01-22-05 - Update Programming Engine/Motor Control Module - J623- for Various Concerns

Release date: 10/10/2022

Revision Table			
Instance Number	Published Date	Version Number	Reason For Update
2068071/2	10/10/2022	01-22-05	Correction to labor operation number in warranty table.
2068071/1	9/22/2022	01-22-05	Original publication.

Figure 1.

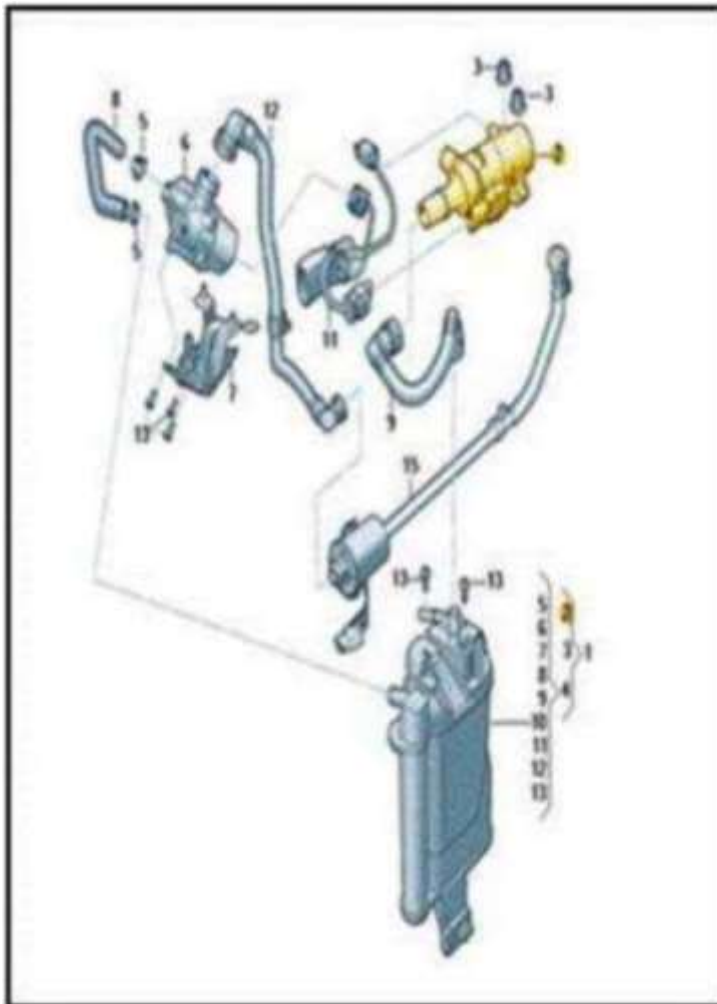
In addition to the software improvement, there is also an improvement to the FTIV (fuel tank isolation valve/tank switch-off valve -**N288**-) (Figure 1.), which is necessary in preventing erroneous occurrences of the P2421 fault code.

The FTIV / Tank switch-off valve -**N288**- currently installed on the vehicle must be inspected, to verify whether an improved part has already been installed. The FTIV / Tank switch-off valve -N288- is mounted to the EVAP canister assembly, as shown below.

Remove the EVAP canister assembly and inspect the face of the FTIV / Tank switch-off valve -**N288**-. If the part is already updated, it will have a white paint marking or "02S" printed after the part number, as shown in Figure 2 and Figure 3.

- If the part has a white paint mark or “02S”, the FTIV / Tank switch-off valve -N288- is already the updated component. In this case DO NOT replace it, and instead reinstall the EVAP canister assembly. Only the software update will be required.
- If there is no white paint mark or “02S” visible on the FTIV / Tank switch-off valve -**N288**-, the component must be replaced in addition to the software update. Always refer to ETKA for the most up to date part number information.
